Access Compliance Report

Public Rights-of-Way

(Curb Ramps)

Intersection ID: 4194	Main Street: COLVARD_PARK_WY	Cross Street: MALLARD_CREEK_RD	Location: NW
ADA ID: 5AFE63E8306C	Ramp Type: Perp	Initial Pass/Fail: Fail	Overall Compliance: No
		Severity Score: 25

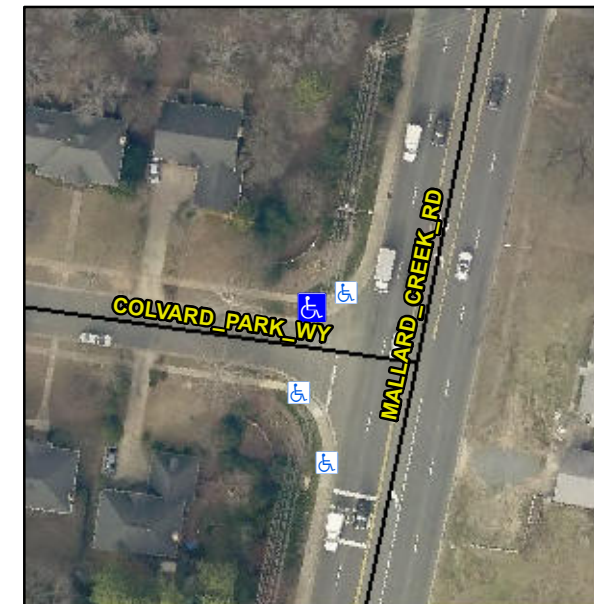
R304.2.2

Compliance	Description	Data	Compliance	Description	Data
N/A	Ramp Length (in)	56.0	No	Ramp Slope (%)	15.1
Yes	Ramp Width (in)	48.0	Yes	Ramp XSlope (%)	1.6
N/A	Flare Type LT	N/A	N/A	Flare Type RT	N/A
N/A	Flare Slope LT (%)	N/A	N/A	Flare Slope RT (%)	N/A
N/A	Flare Traversable LT?	N/A	N/A	Flare Traversable RT?	N/A
N/A	Landing Length (in)	N/A	N/A	DWS Provided?	N/A
N/A	Landing Width (in)	N/A	N/A	DWS Contrast?	N/A
N/A	Landing Slope (%)	N/A	N/A	DWS Length (in)	N/A
N/A	Landing X Slope (%)	N/A	N/A	DWS Full Width?	N/A
N/A	Landing Curb? (Y/N)	N/A	N/A	DWS Offset (in)	N/A
N/A	Shared Landing?	N/A			
N/A	Gutter Ponding?	N/A	N/A	Gutter Slope (%)	N/A
N/A	Gutter Lip Ht (in)	N/A	N/A	Gutter X Slope (%)	N/A
N/A	Painted X Walk1?	No	N/A	Painted X Walk2?	N/A
	X Walk 1 Direction	To S		X Walk 2 Direction	N/A
N/A	X Walk 1 Width (in)	N/A	N/A	X Walk 2 Width (in)	N/A
	X Walk 1 Slope (%)	0.6		X Walk 2 Slope (%)	N/A
	X Walk 1 X Slope (%)	3.3		X Walk 2 X Slope (%)	N/A

Possible Solutions:

Remove & Replace Entire Ramp.
